Work Order # 104671

Item Name: 1/2" Crosstube - High

DRAWING NO. REV. D
D212-664-141 SHEET 1 OF 4
TITLE SCALE
XTUBE ASSY (205/212/412 HI FWD) NTS

DRAWING NO. D212-664-141	TITLE XTUBE ASSY (205/212/412 HI FWD)	REV. D	DART AEROSPACE LTD ENGINEERING ORDER		D.E.O. NO. D212-664-141-D-1	SHEET NO. SHEET 1 OF 2	SCALE NTS
DRAWN	CHECKED	OP	MFG. APPR.	APPROVED	NP	DE APPR.	
DATE 11.04.07	DATE 11.07.11		DATE 11.04.12	DATE 11/04/12		DATE 11.04.12

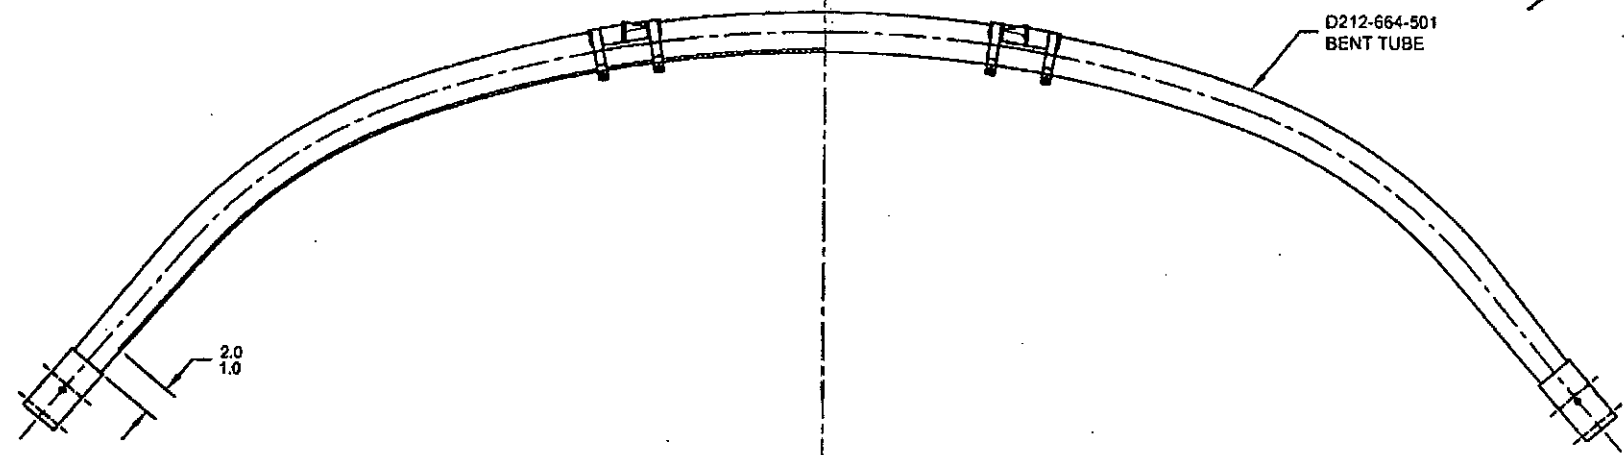
ADD AN INSPECTION WINDOW TO UNDERSIDE OF CROSSTUBE.

NOTES 2 OF SHEET 1 IS AMENDED AS FOLLOWS:

- 2) FINISH: CHEMICAL CONVERSION COAT PER DART QSI 005 4.1
PRIME INSIDE AND OUTSIDE PER DART QSI 005 4.2
MASK UNDERSIDE OF CROSSTUBE AS SHOWN (HATCHED AREA) AND
PAINT OUTSIDE PER DART QSI 005 4.2
REMOVE MASKING AND APPLY CLEAR COAT

MASK AREA PRIOR TO PAINTING,
REMOVE MASKING AFTER PAINT
AND APPLY CLEAR COAT
